**PLANNED UNIT DEVELOPMENT
STAFF REPORT****Date: March 19, 2015****DEVELOPMENT NAME**

Grant Harkness

LOCATION1607 E I-65 Service Road South
(East side of East I-65 Service Road South, 820'± North of
I-65 Commerce Drive)**CITY COUNCIL
DISTRICT**

CONTEMPLATED USEPlanned Unit Development Approval to amend a
previously approved Planned Unit Development to allow
an additional building.**TIME SCHEDULE
FOR DEVELOPMENT**

SITE PLAN

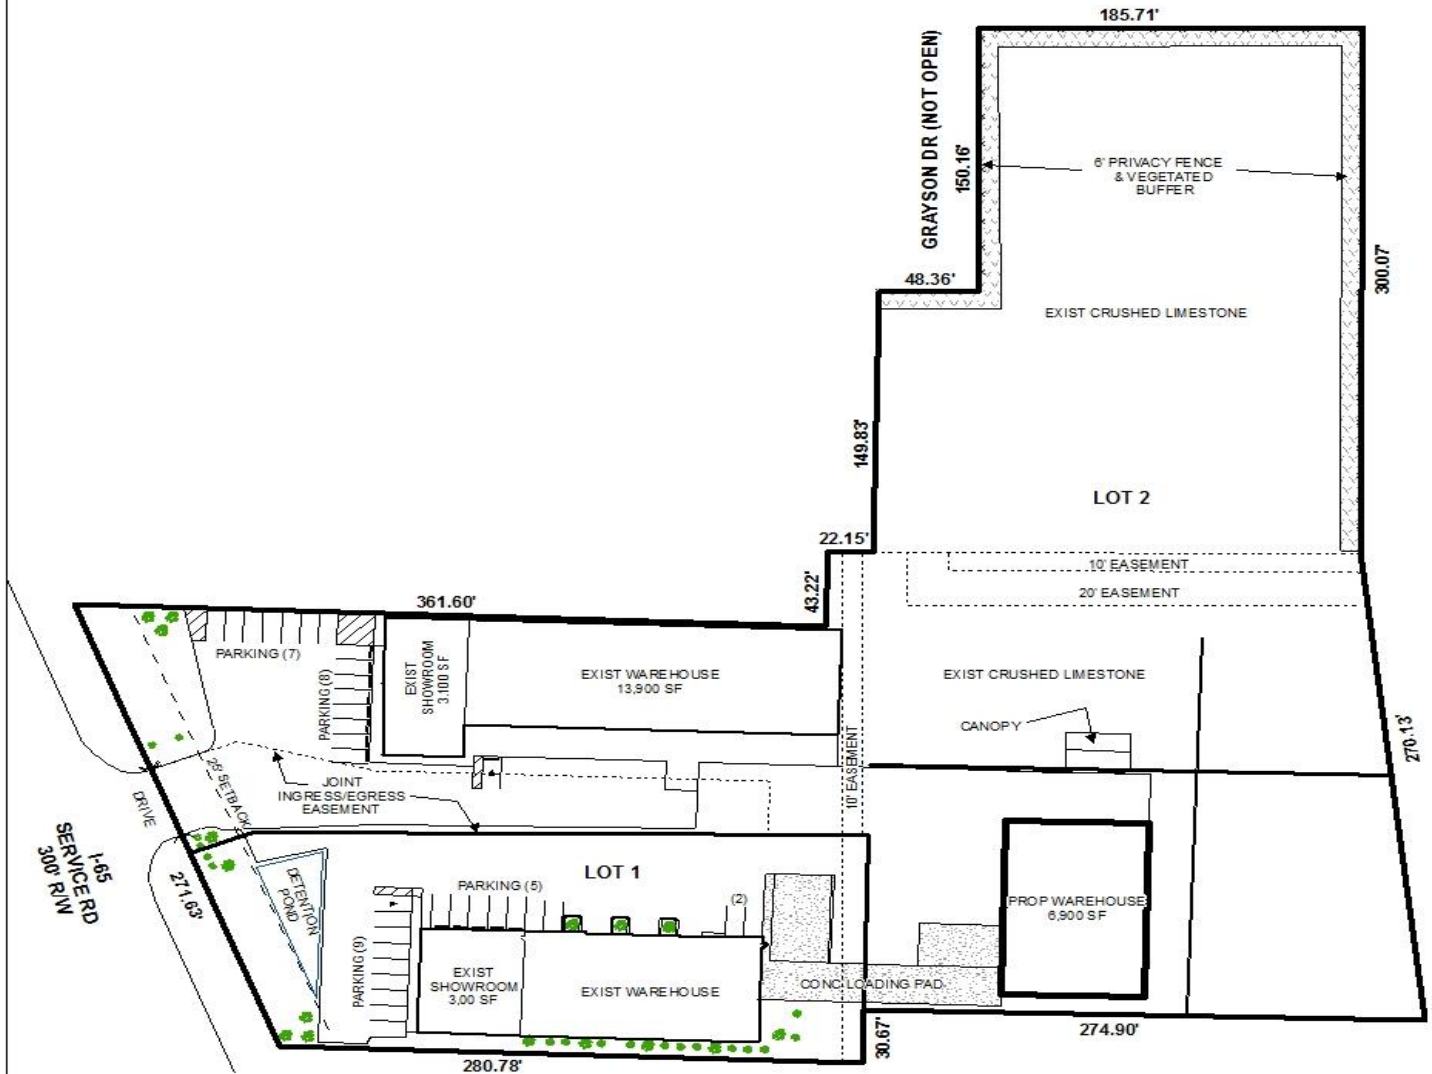
The site plan provides information regarding parking on Lot 2, but does not include Lot 1. Based on the existing 3,000 square foot showroom and warehouse, it appears that Lot 1 will have sufficient parking as long as there are no more than 24 warehouse employees. The site plan should be revised to include parking calculations for both lots.

No new tree plantings are proposed for the site, and the submitted site plan matches previously approved tree plans for the site; however Lot 2 was previously required to have frontage trees only. Because the proposed warehouse will result in an increase of more than 50% of building area, Lot 2 should be required to come into full compliance with tree planting and landscaping requirements.

Regarding Lot 2, the site plan indicates that the bulk of Lot 2 is crushed limestone, and it appears to serve as a storage area that has been expanded since 1984, with no apparent permits. It should be noted that while the site did obtain variances to allow gravel surfacing for the parking area in the front of the site, the variance approval expired in 2011, and the applicant did not express a desire to have a gravel storage area on site. All storage areas in B-3, Community Business Districts are required to be paved with asphalt or concrete.

Furthermore, the aerials show that the storage area for Lot 2 contains other buildings not indicated on the PUD site plan, that it appears to accommodate employee parking on gravel surfacing, and that a variety of truck trailers, trucks and other equipment are stored in the rear area: one of the Planning Commission conditions of the approval from 2005 is *"the submission and approval of a Planning Approval application if the heavy equipment rental operation is expanded."* Thus the applicant should provide a more detailed description of the activities on the site, and should revise the site plan to accurately reflect all existing buildings, and improvement of the entirety of the site to meet paved surfacing requirements of the Zoning Ordinance.

It should be noted that the submitted site plan shows a 10' water and sewer easement as well as a 20' sanitary sewer easement on the rear portion of Lot 2 which was not indicated on any of the previous Subdivision, Planned Unit Development, or Variance site plans. Furthermore, there is an existing building located on top of these easements. Due to the location of the easements, the structure should be relocated, or the easements vacated.

There is a note on the site plan indicating that preservation status will be granted to “the 42” Live Oak Tree located on the North side of Parcel A”. There is no such tree illustrated on the site plan, nor has Urban Forestry made such a stipulation for this site. If this note was indeed placed on the site plan by mistake, it should be removed.

The applicant was asked to revise the site plan to show all existing buildings on the site, and label their use and size. Instead, the site plan was revised to illustrate all permanent buildings on the subject site. The revised narrative states that items that "The items that appear on the aerial photograph consist of portable storage pods, temporary tent-type structures, and miscellaneous rental equipment. There is one small portable shed located on the site." This, however, does not explain the disappearance from the site plan of an approximately 1,250 square foot structure previously illustrated on the site plan in existing easements. The applicant was requested to illustrate all existing buildings on the site, not just what they deem as permanent.

The site plan has been revised to show continuous asphalt paving from the parking area in the front of the site continuing to the newly proposed warehouse for fire truck access. Regarding paving requirements for the storage area on Lot 2, the applicant states the following:

After reviewing aerial photographs, it appears that the storage area has indeed been expanded slightly since 1997, and significantly since 1984 with no permits. The fact that the applicant has expanded the storage area significantly without permits over the past 31 years is not sufficient justification to allow the continued use of inappropriate surfacing materials. Furthermore, it appears that the area is used for employee parking. Therefore, the site plan should be revised to illustrate a compliant surfacing for the storage area, or obtain a variance to allow continued use of aggregate surfacing.

- 1) obtaining Planning Approval to allow heavy equipment rental and leasing in a B-3, Community Business District;*
- 2) revision of the site plan to show full compliance with the paving requirements of the Zoning Ordinance, or obtaining a variance to allow continued use of aggregate surfacing;*

- 3) provision of tree plantings as required by the 2005 Planned Unit Development approval;*
- 4) placement of a note on the site plan stating that any future expansions will require full tree planting and landscape area requirements;*

- 5) provision of a residential buffer compliant with Section 64-4.D.1. of the Zoning Ordinance;*
- 6) illustration of **all** buildings on the site;*
- 7) comply with Engineering comments (ADD THE FOLLOWING NOTES TO THE PUD SITE PLAN: 1. Any work performed in the existing ROW (right-of-way) such as driveways, sidewalks, utility connections, grading, drainage, irrigation, or landscaping will require a ROW permit from the City of Mobile Engineering Department (208-6070) and must comply with the City of Mobile Right-of-Way Construction and Administration Ordinance (Mobile City Code, Chapter 57, Article VIII). 2.A Land Disturbance Permit application shall be submitted for any proposed land disturbing activity with the property. A complete set of construction plans including, but not limited to, drainage, utilities, grading, storm water detention systems, paving, and all above ground structures, will need to be included with the Land Disturbance permit. This Permit must be submitted, approved, and issued prior to beginning any of the construction work.*

- 9) provision of two (2) revised PUD site plans to the Planning Section of Urban Development prior to issuance of any permits.
